City of Ketchum

Recommendation to Hold a Public Hearing and Approve the Beck Readjustment of Lot Lines / Final Plat with conditions 1-7 included in the draft Findings of Fact, Conclusions of Law, and Decision

A PLAT SHOWING BECK SUBDIVISION

IN RE:)	
)	
Beck Subdivision)	KETCHUM CITY COUNCIL
Final Plat)	FINDINGS OF FACT, CONCLUSIONS OF LAW, AND
Date: December 2, 2019)	DECISION
)	
File Number: 19-124)

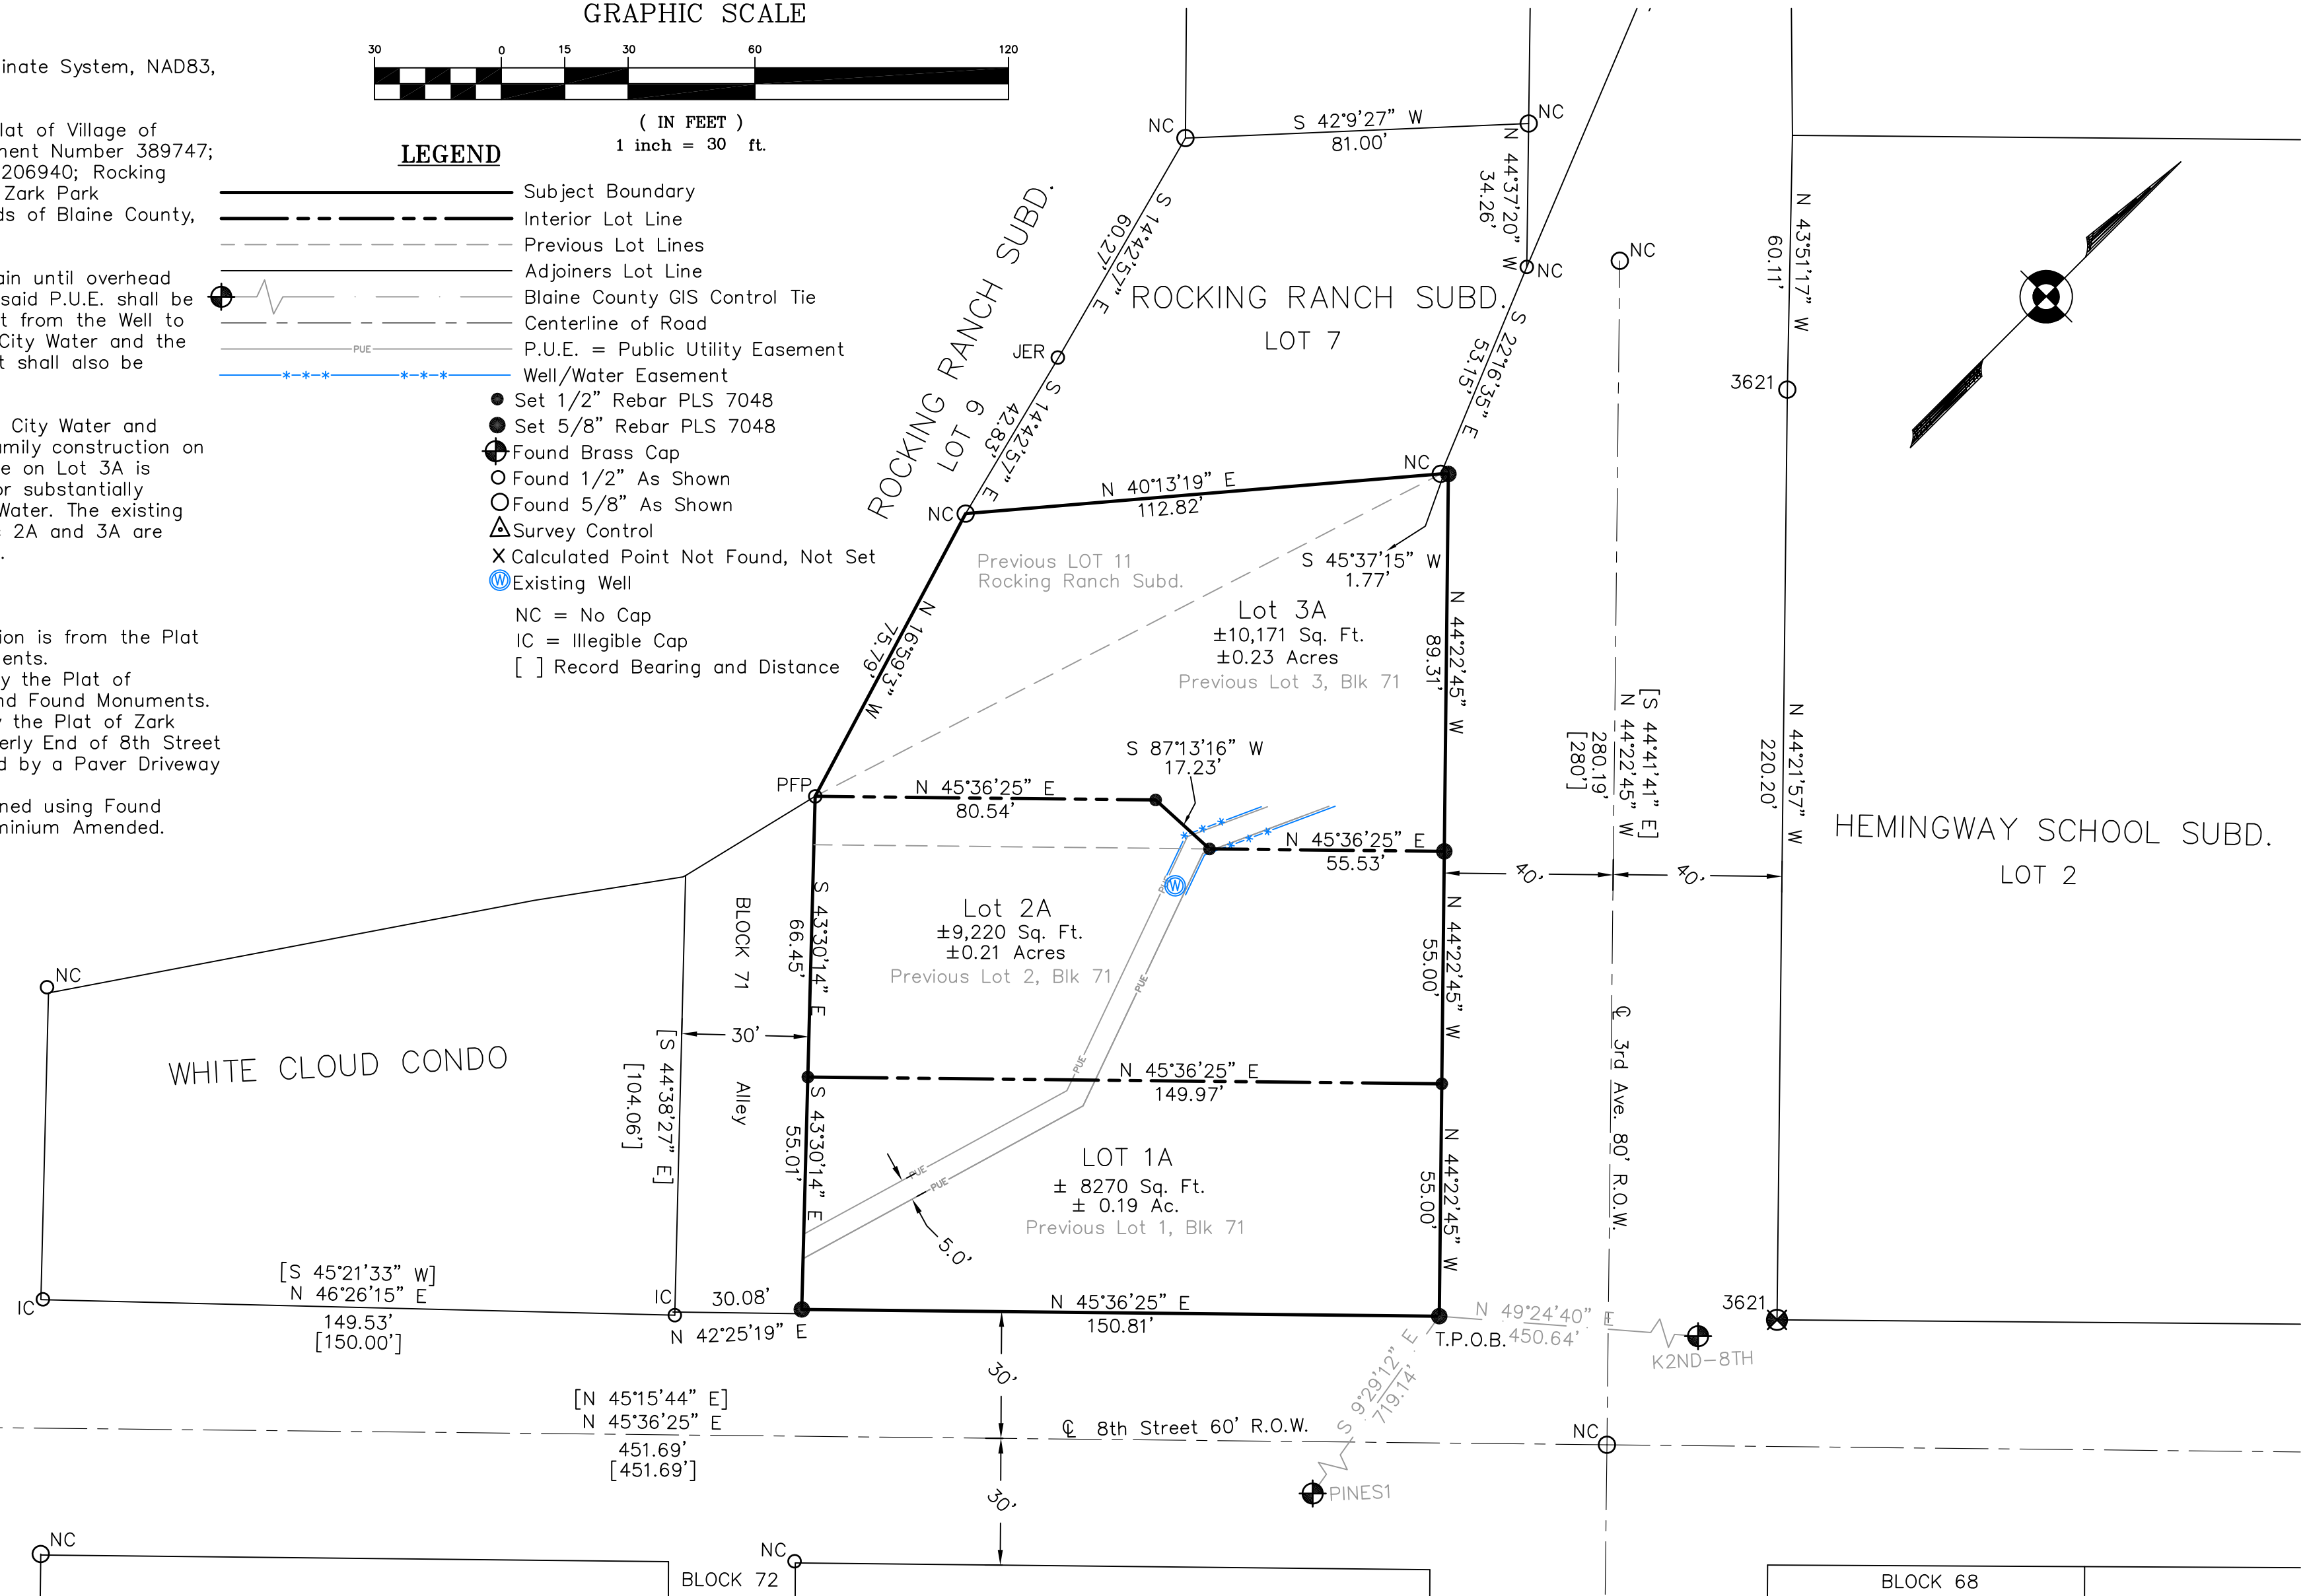
- The project reconfigures four existing lots into three new lots consistent with the city's recently revised subdivision and readjustment of lot line procedures (See Ordinance #1198).
- The three new lots, referenced as Beck Subdivision Lots 1A, 2A and 3A of Block 71, incorporate Lot 11 of Rocking Ranch Subdivision, which is recognized on the plat as being substandard @ 3,602 square feet in size and as needing to become a part of the Beck Family Property, as referenced in instrument # #230763.
- Each of the 3 new reconfigured lots meet GR-L minimum lot sizes and, thus, eliminate a substandard lot, although new Lots 1A and 2A still have average lot widths less than 80' (55' and +/- 65', respectively).

With the exception of the minimum lot widths of Lots 1A and 2A and the existence of a small shed within the rear/side setback of Lot 1A, the Project meets all city standards. Consistent with this notation on the shed, staff has conditioned the plat such that the footprint of the shed in the southwest corner of Lot 1A may not be expanded. Finally, subject subdivision is on the city's sewer system, but not the city water system which the director of the city's water and sewer system does not find to be an issue. At the discretion of the City, staff recommends that future single-family development of Lots 1A, 2A, or 3A of Beck Subdivision may require connection to the city water system.

1. The recorded plat shall show a minimum of two Blaine County Survey Control Monuments with ties to the property and an inverse between the two monuments. The Survey Control Monuments shall be clearly identified on the face of the map.

4. The Final Plat mylar shall contain all items required under Title 50, Chapter 13, Idaho Code as well as all items required pursuant to KMC §16.04.030J including certificates and signatures.
5. All governing ordinances and department conditions pertinent to the Fire Department, Building Department, Planning Department, Street Department and Ketchum City Engineer shall be met.
6. At the discretion of the City, future single-family development of Lots 1A, 2A, or 3A of Beck Subdivision may necessitate site infrastructure improvements, including connection to the city water system.
7. Neither the footprint or the volume of the shed in the southwest corner of Lot 1A may be expanded.
